Subject: FW: [EXTERNAL]Fwd: The Union Leauge- Vulcan follow up
From: Roxanne Holt <Roxanne.Holt@vulcanhart.com>
Date: 1/27/2022, 11:51 AM
To: "ddb@davidbethel.com" <ddb@davidbethel.com>

Please see email below and attached drawing for the modular Vulcan Suite for TULP.

Please see attached drawings as well as below comments. The main question or item to be confirmed is, would you like us to keep the 2" of spacing between equipment to make it easy to remove/replace equipment or battery the equipment together?

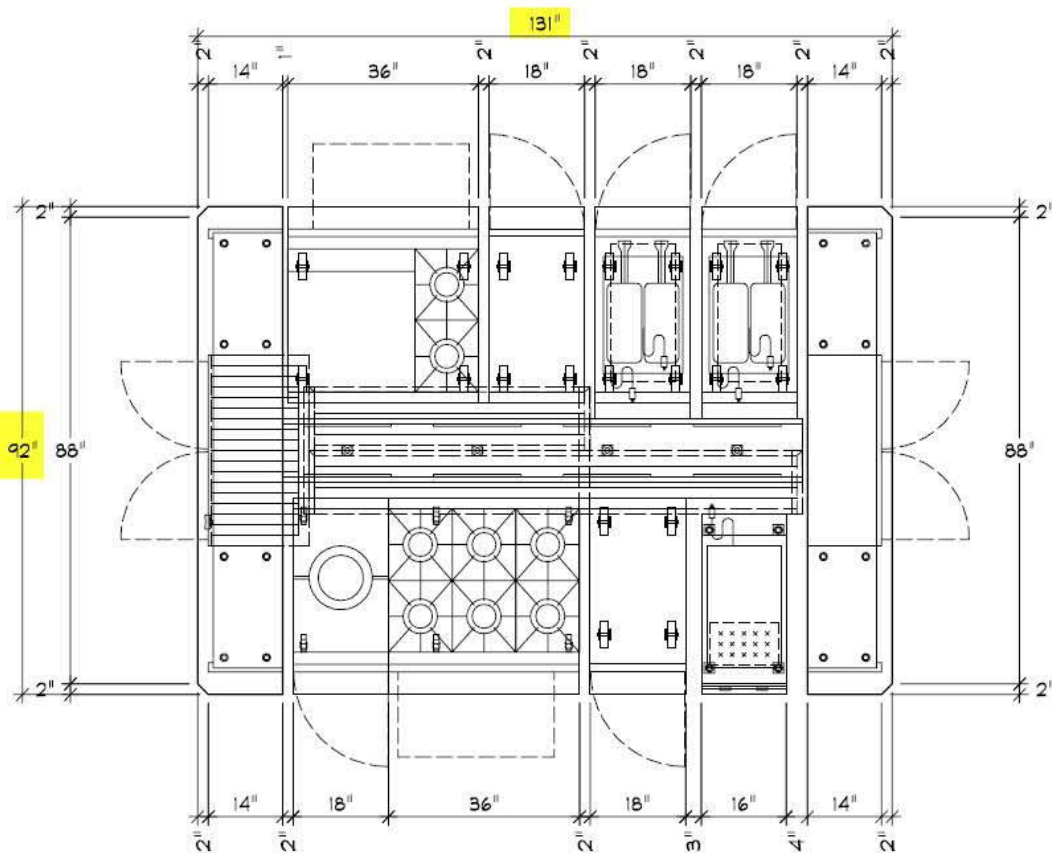
1. Change the Cheesemelter to VICM36 / not Pass Thru
2. Change the open shelving under the VICM to have doors (as it is customer facing)
3. Add Casters to the Pasta Cooker
4. Close the spacing to 1" between all equipment. They want it tight. Reduce overall dimension to be 10'6"x 7'2"
5. Rear Gas Connection to a single point in the cabinet opposite the cheesemelter

1. With a traditional suite, equipment typically is tucked under the heat bridge at the center. As this is an H frame suite, with the ability to remove equipment easily being central to its design, the equipment will sit in front of the heat bridge – extending the depth of the suite a few additional inches. **OK**

2. Structurally, the support for the Cheesemelter will now need to come from the cabinet below it, rather than being supported by the heat bridge or the range equipment – since they are separate components, so the end cabinet under the cheesemelter has to include additional support for that unit. **ok**

3. David included ~2" of space at the sides of either end of equipment to easily pull the equipment out.
 - a. Is accessibility to pull equipment off the line a "worst case scenario" thing (where I can eliminate the spacing/battery equipment together)

- b. or do they plan to "plug and play" often where the spacing/individual units is needed to quickly pull equipment out individually? **From the sound of it they would like to switch the equipment out every year or two when they change the menu. I would tighten up to 1" instead of 2".**
